Technical Memorandum

Subject: Interim As-Built Survey for the Strawberry Creek Restoration Project at Redwood National Park in Orick, CA (CDFW FRGP #P1110508)

Attachment 1: Interim As-Built Plans (11,7/14)

STRAWBERRY CREEK RESTORATION PROJECT

LAYOUT SHEET 1

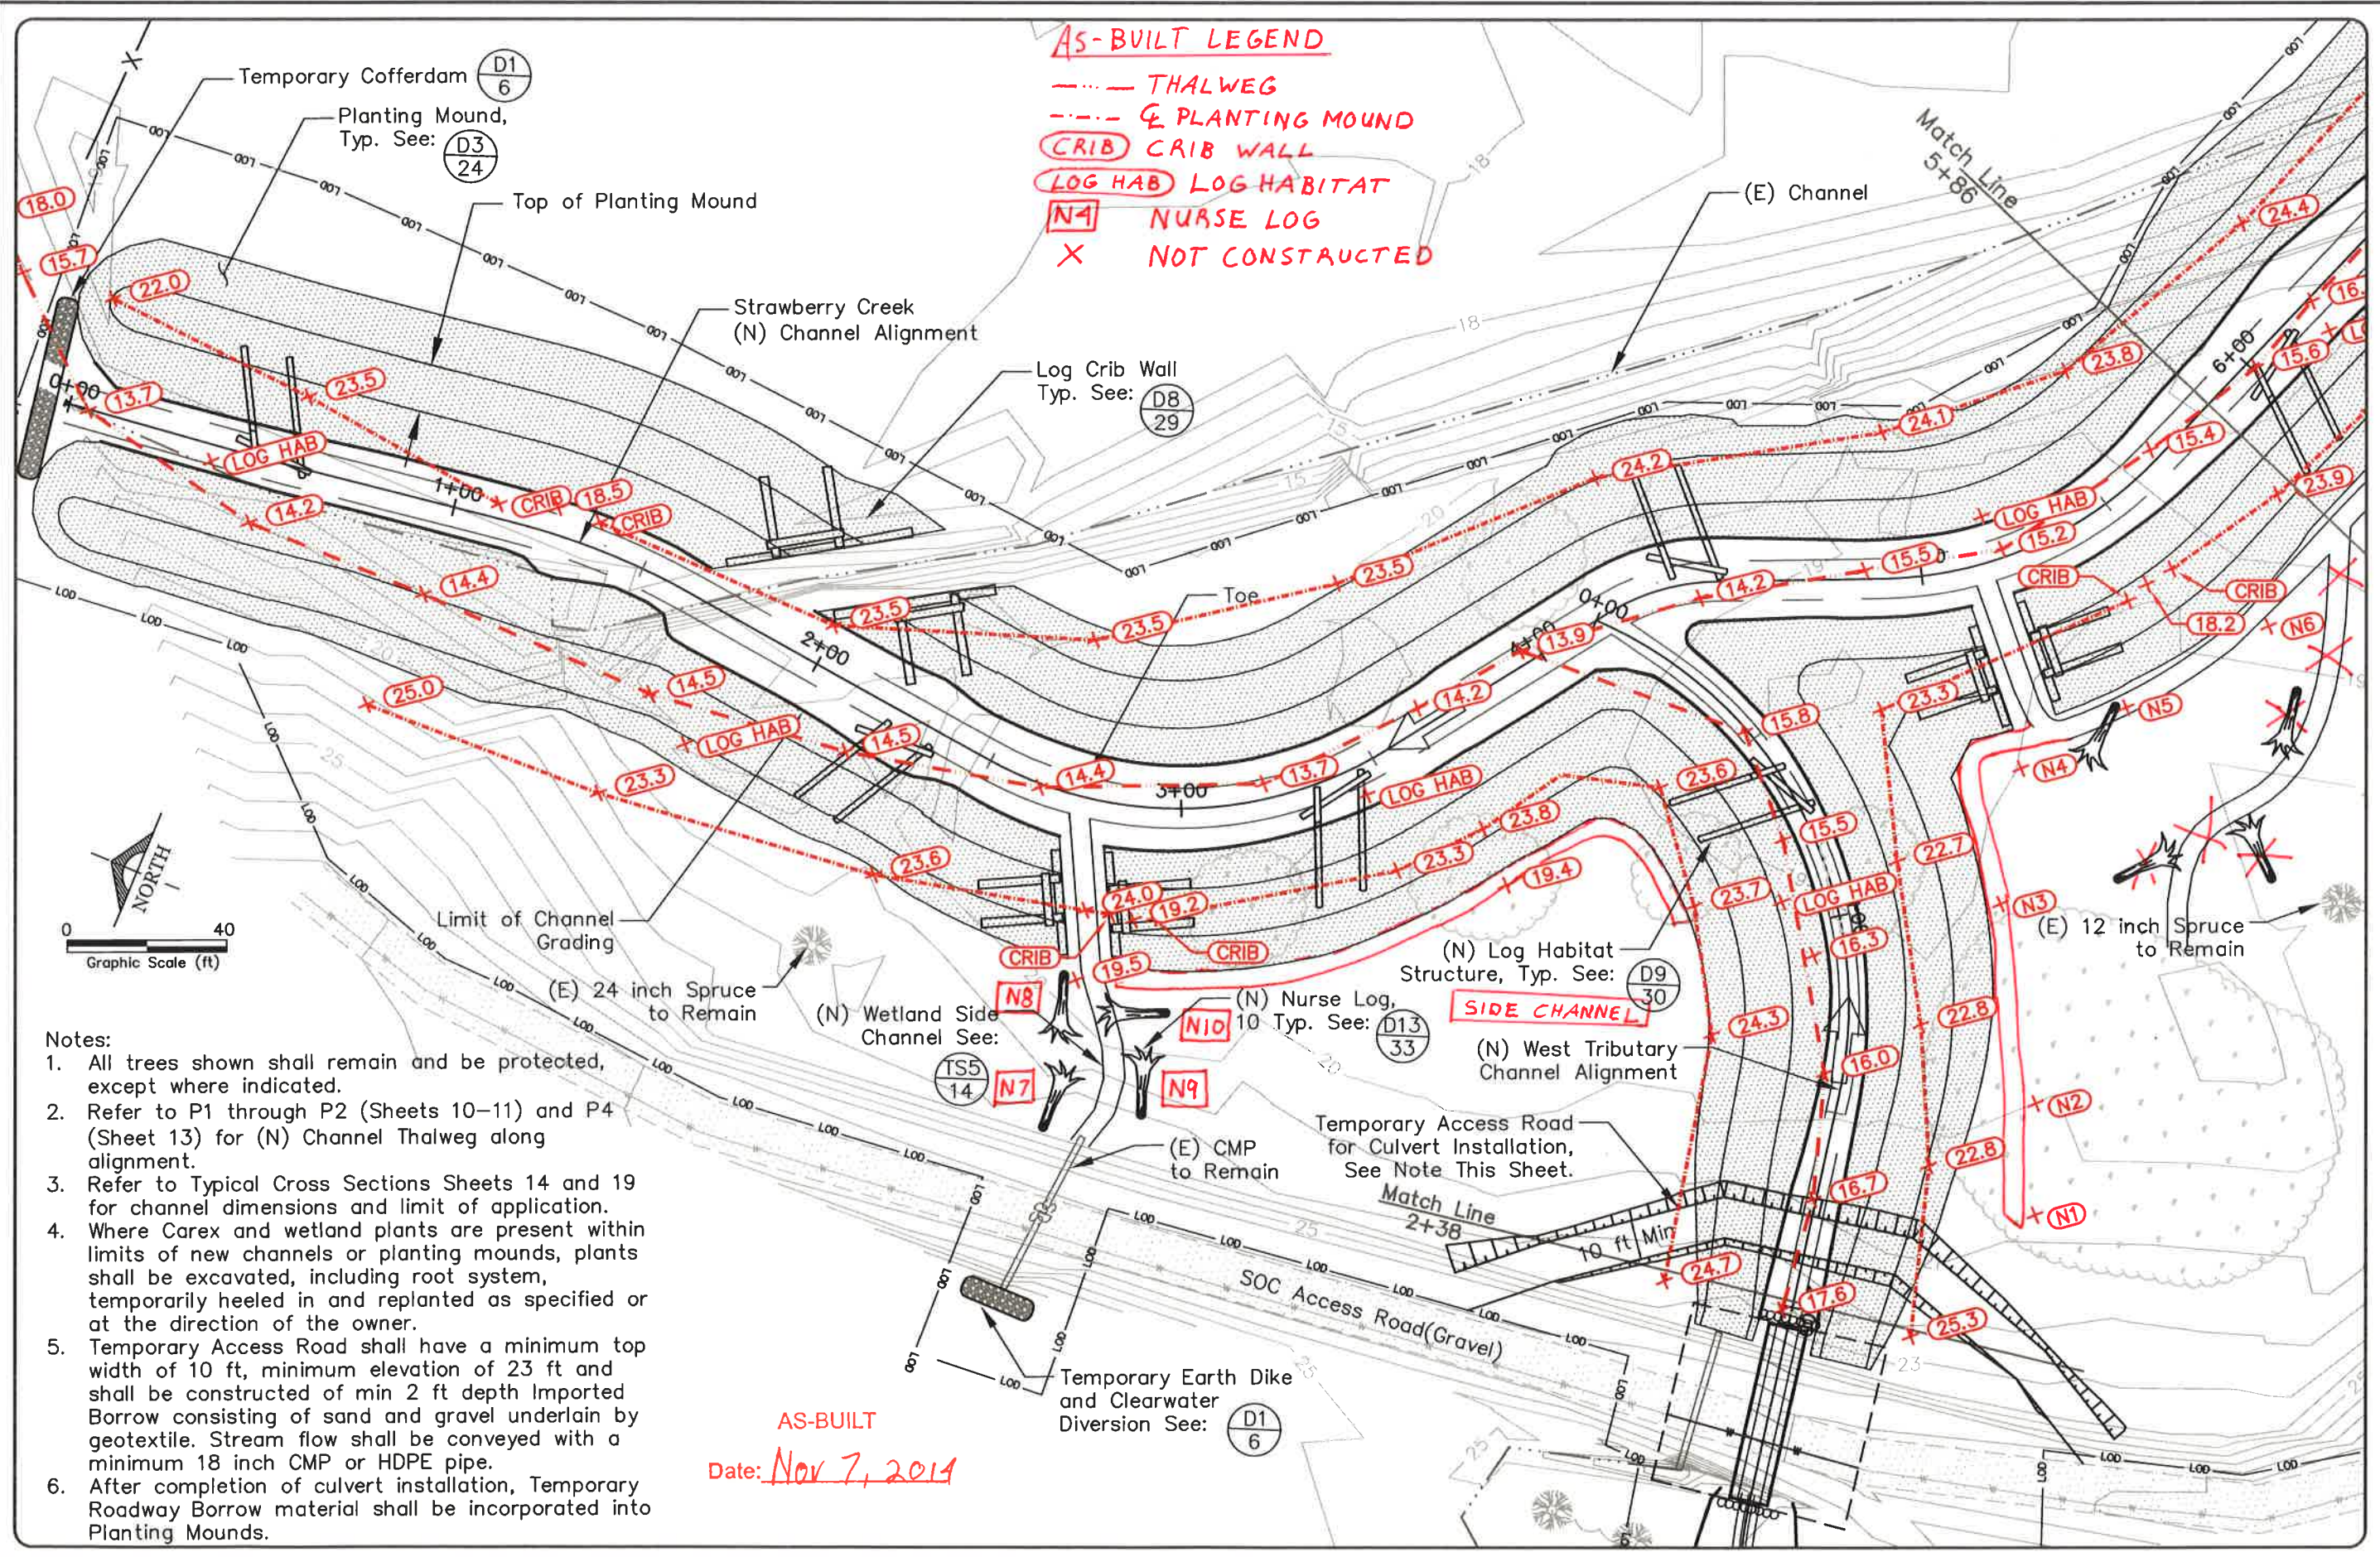
AS-BUILT LEGEND
--- THALWEG
--- & PLANTING MOUND
CRIB CRIB WALL
LOG HAB LOG HABITAT
N4 NURSE LOG
X NOT CONSTRUCTED

NOT CONSTRUCTED
NOV 7, 2014

P4
7,9,26,27
WEST FORK TRIBUTARY CULVERT
Profile1

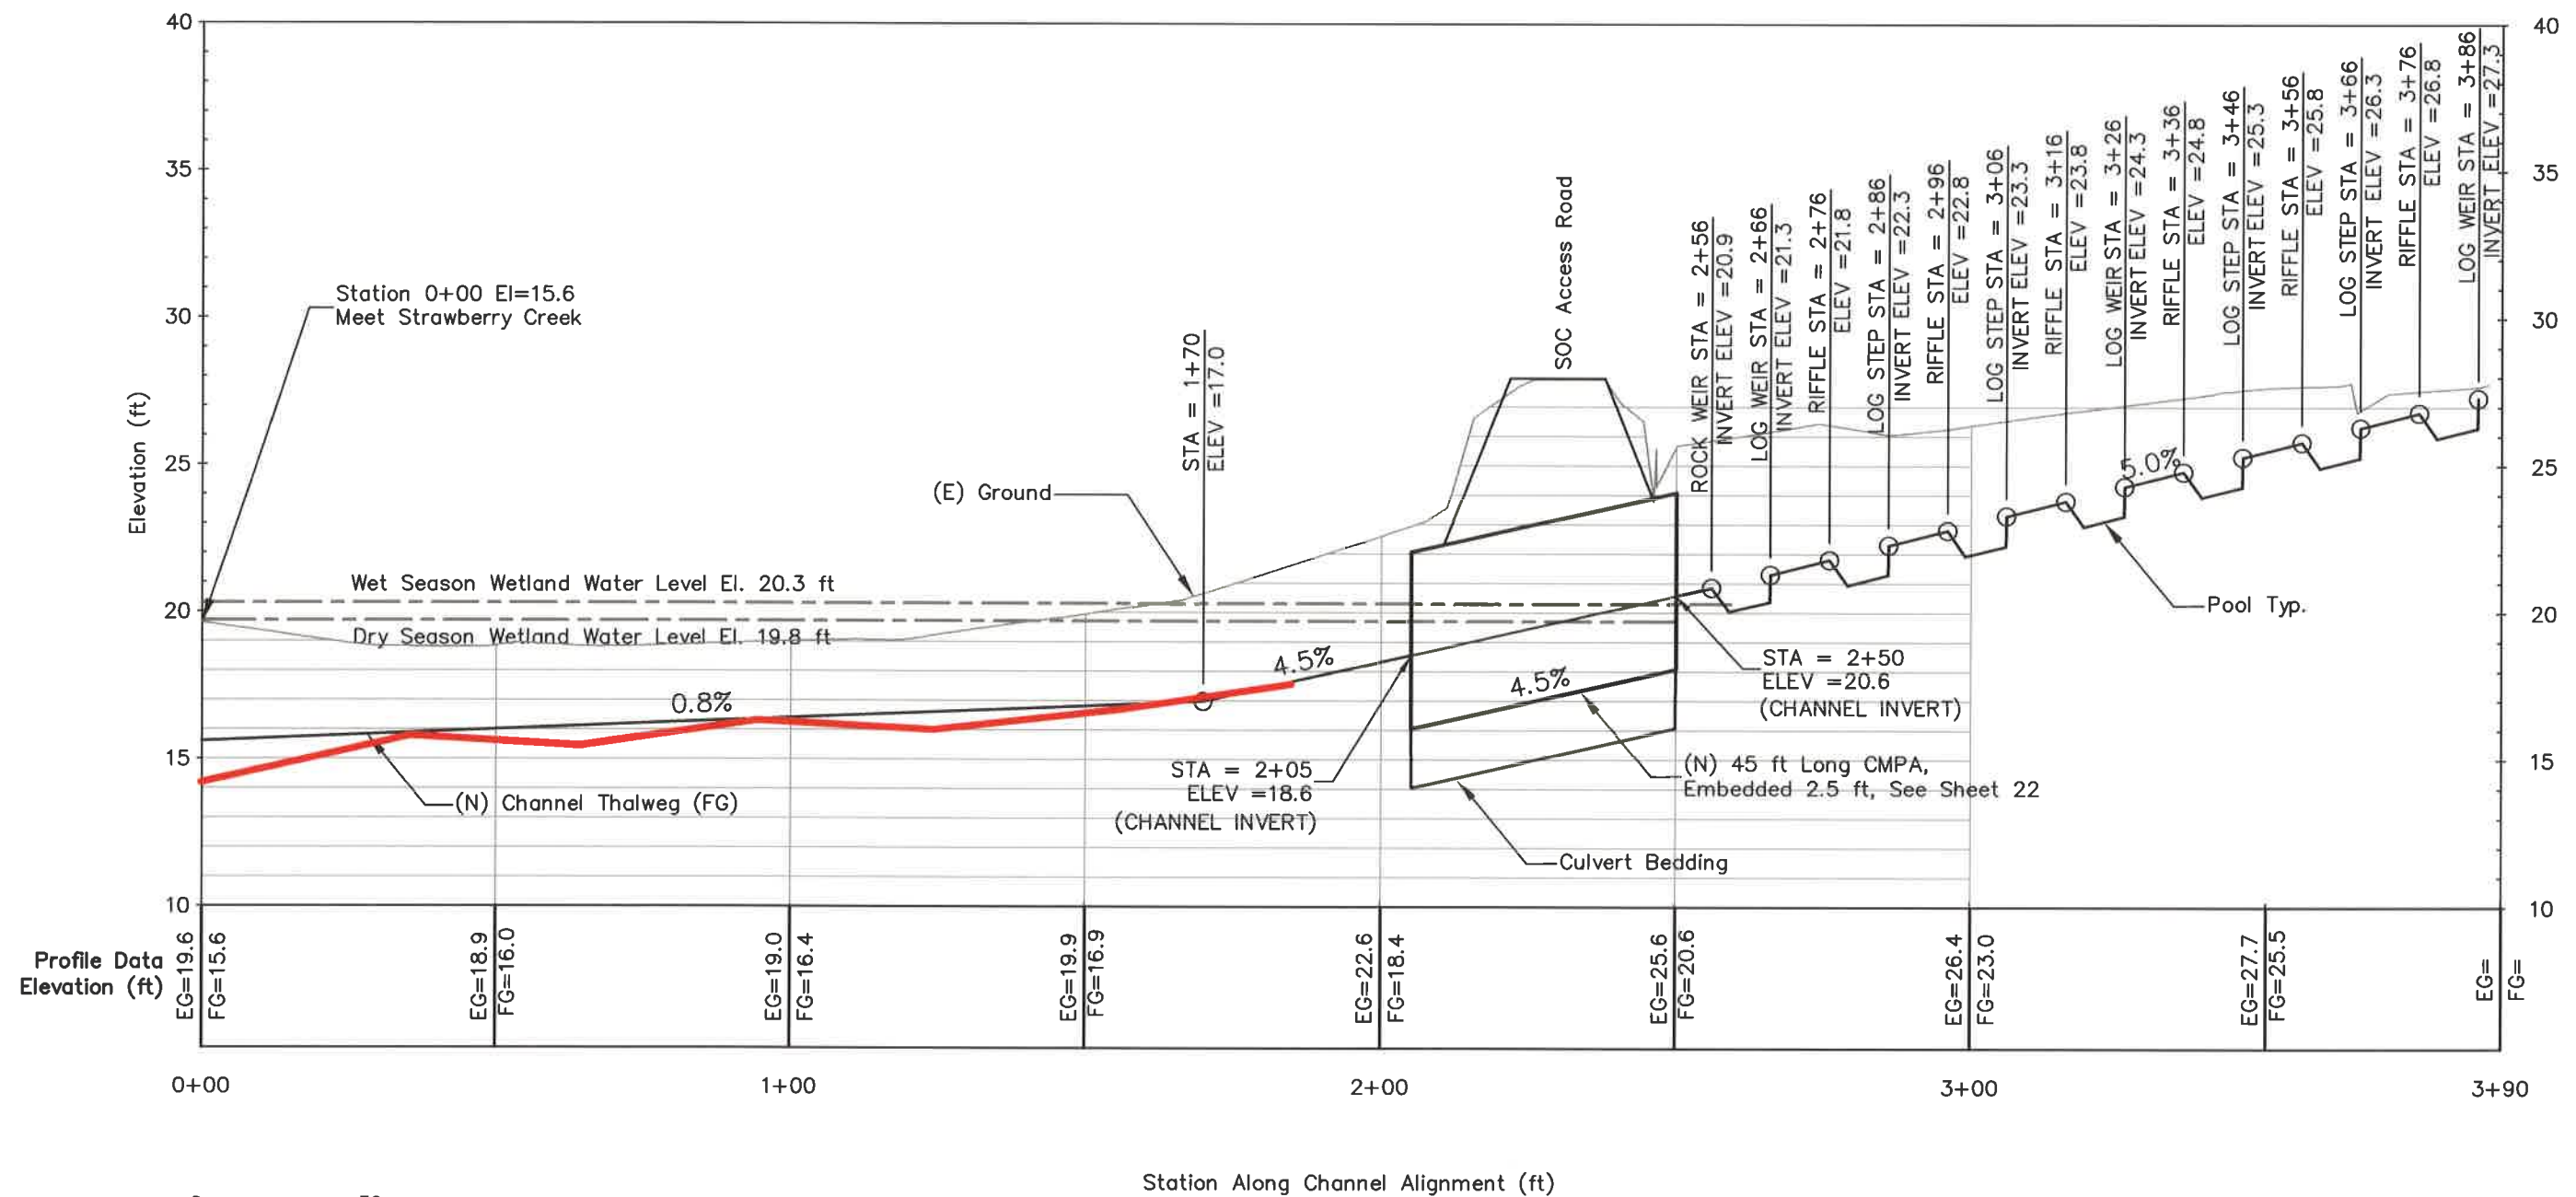
AS-BUILT
Date: NOV 7, 2014
UPSTREAM 1+85
NOT CONSTRUCTED

WEST FORK TRIBUTARY
TYPICAL CROSS SECTIONS

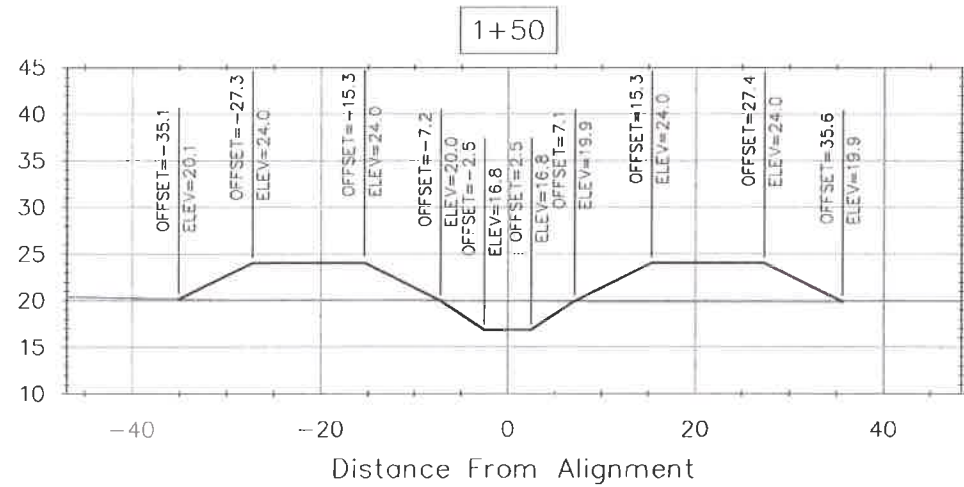
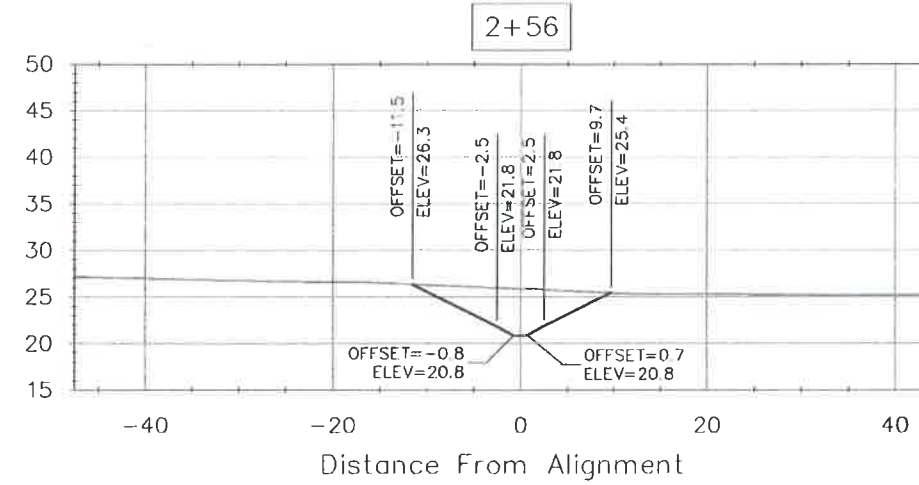
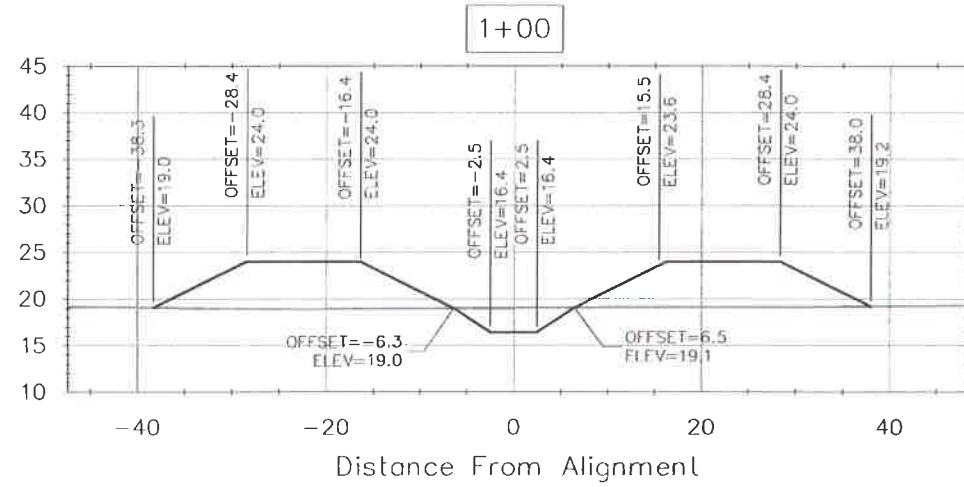
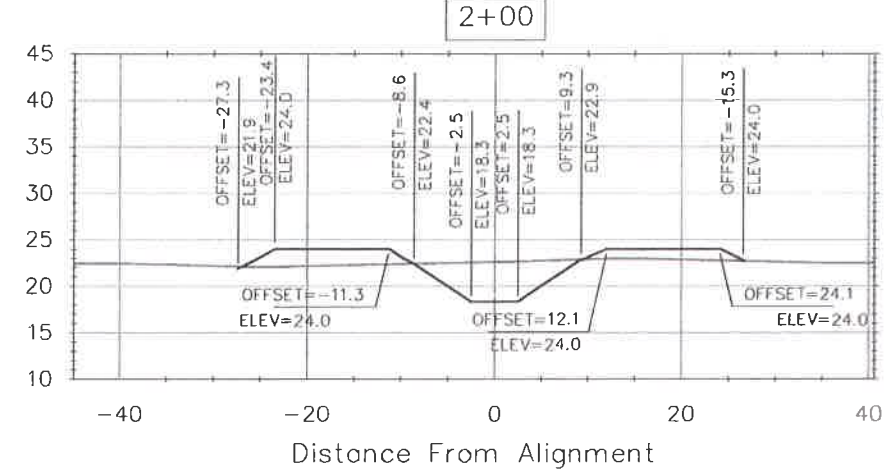
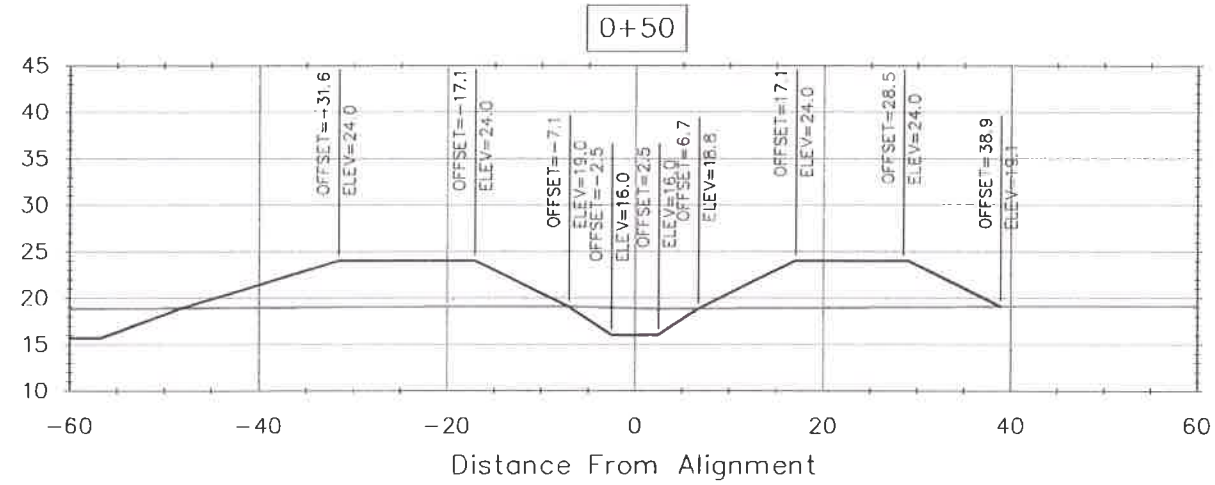
NOT CONSTRUCTED
NOV 7, 2014

D2
22 Culvert Stream Simulation Channel
Typical Cross Section (NTS)

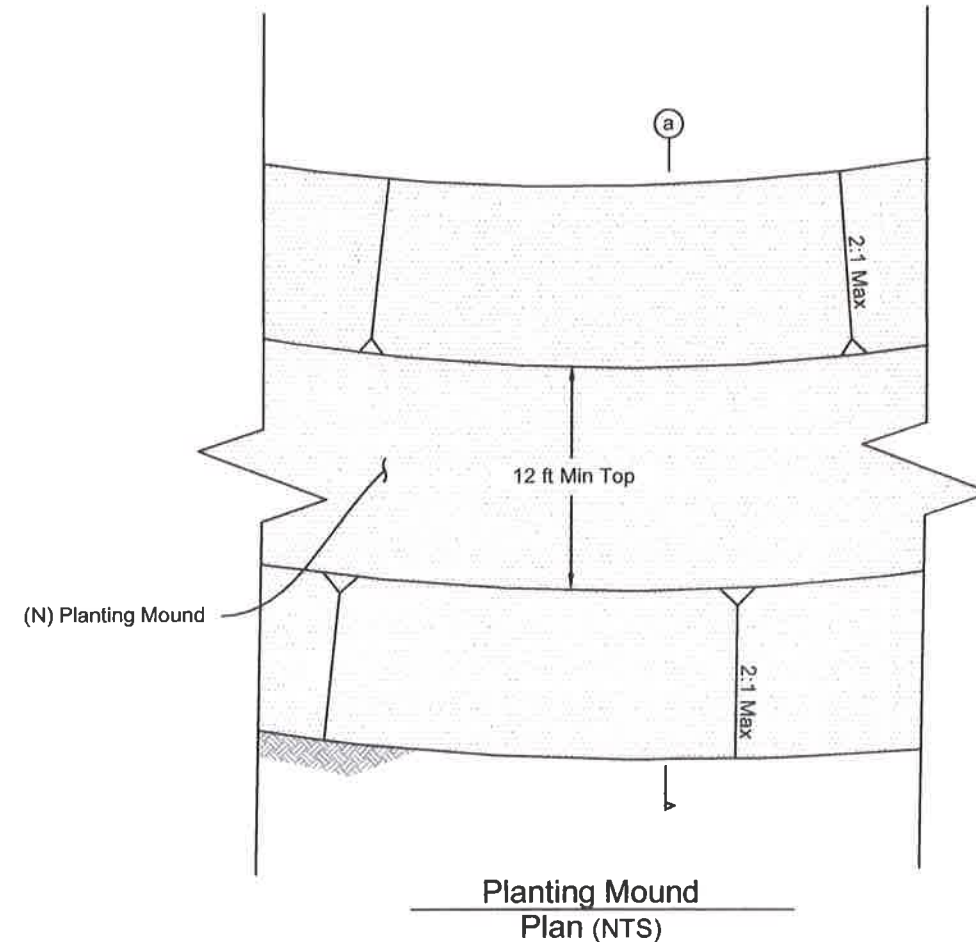
NOT CONSTRUCTED
NOV 7, 2014

D10 8 RSP CULVERT OUTLET DETAIL (NTS)

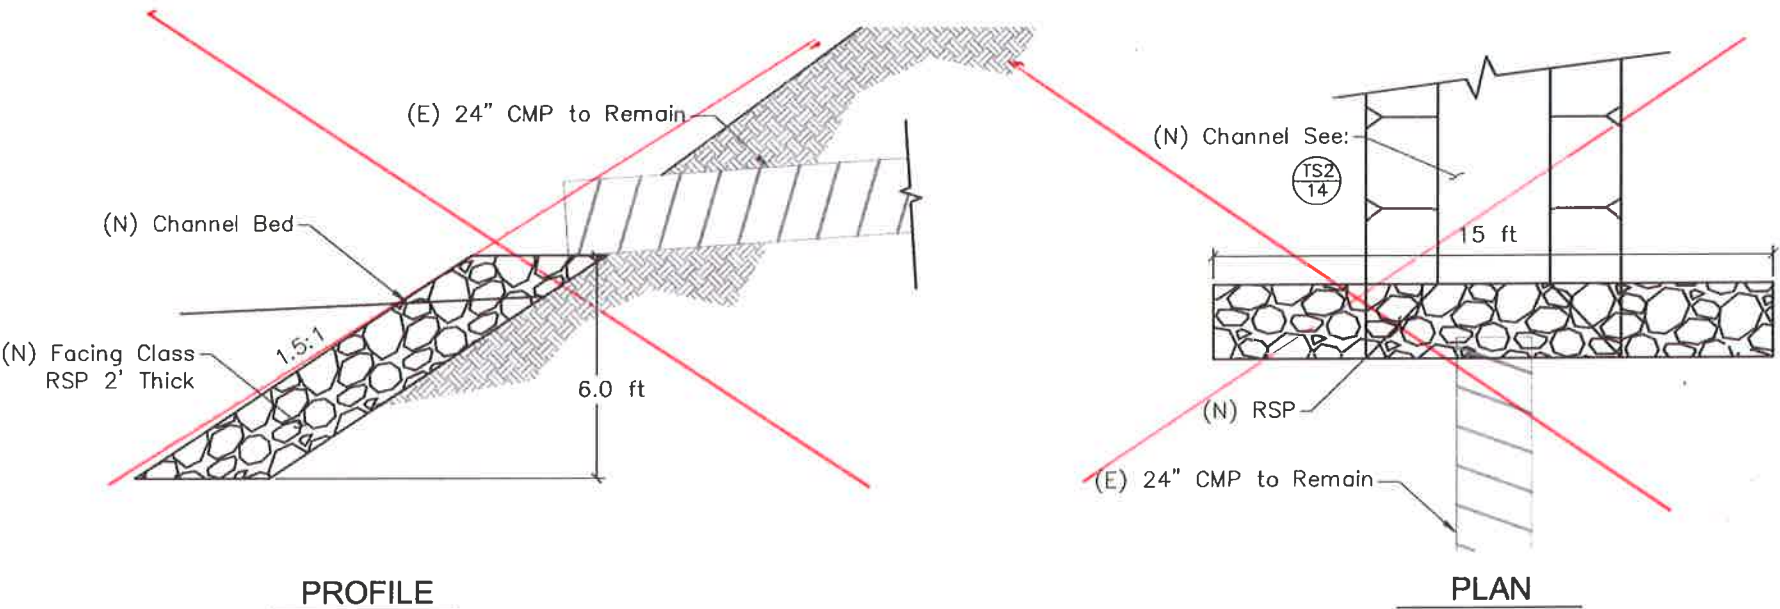
REPLACED WITH ROCK WEIR
AND 2 LOG V-WEIRS
